- Existing Official Plan Protection and Additional Protection Identified through the study**
- Existing, current street lay out and access to Waste treatment water plant**
- Proposed shift to access Waste water plant from study recommendation**

Bradford Street EA - Property Protection Recommendations @ 244, 246, 248 Bradford St

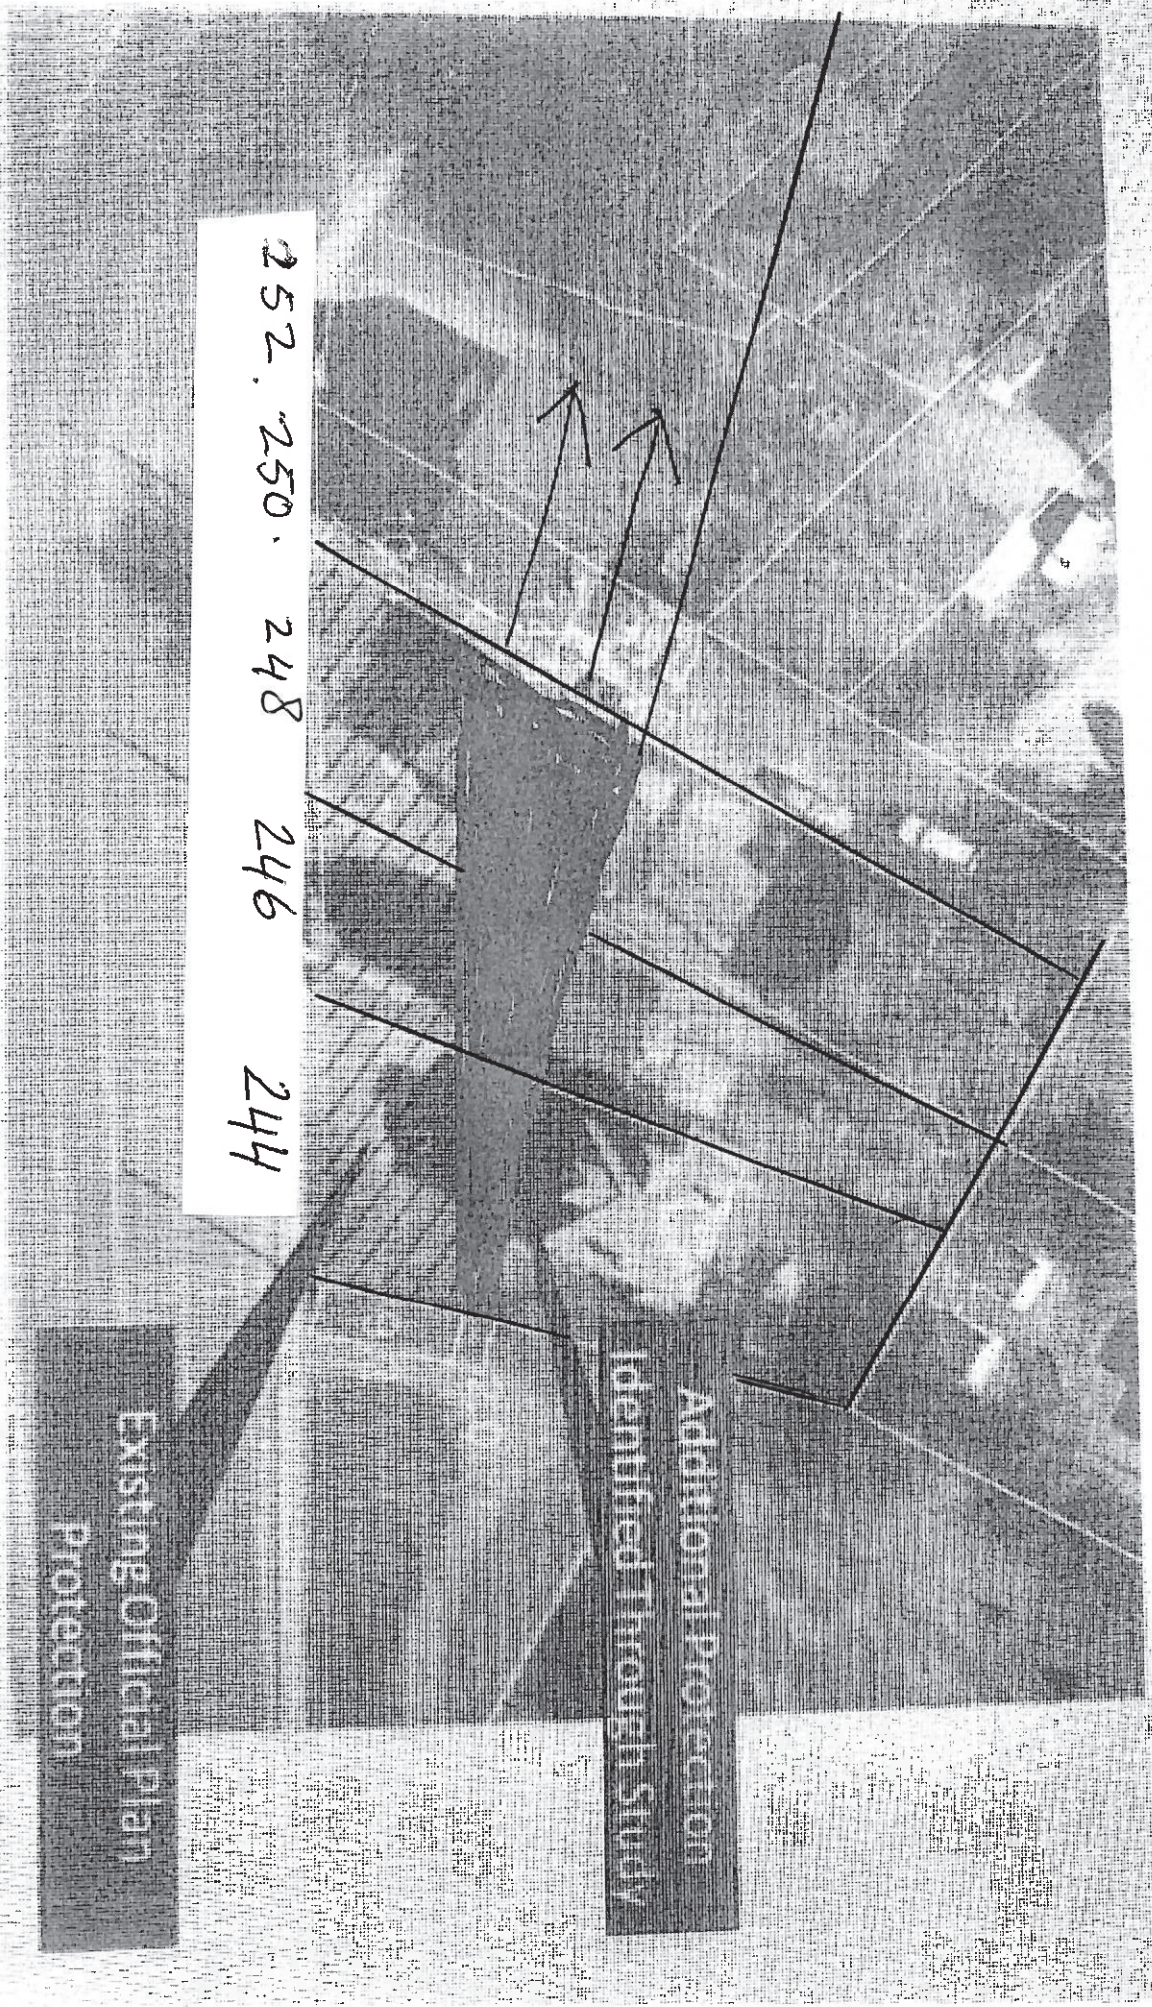
For a specific impact on developable lands zoned high density I would like to refer to the pictures attached showing how much developable land is taken away under the existing official plan for 244,246 and 248 Bradford Street this would also affect the neighboring properties 250 and 252 Bradford Street.

With the proposed road widening taken away of roughly 759.77 square meters this would equate to 48 units lost.

Over and above the Existing Official Plan even more High Density Zoned land is taken away through Additional Protection Identified through the study (see pic attached blacked out area) which is completely avoidable.

If you refer to the pictures of the Existing Current Road and the proposed road, why do we require to shift the access into the waste treatment plan when I have seen hundreds of trucks accessing the plant with no problems at all?

From the attached pics we can all see the impact on high density zoned lands and the Additional Protection Identified through the study is unnecessary and can completely be avoided by not straightening the existing road and not shifting the access into the waste treatment plan.

With respect to our properties, we ask that if the recommendation is to be approved it will be approved within the existing 34-meter ROW and remove the Additional Protection Identified through the study (see pic attached blacked out area).

SHIFT WHY?
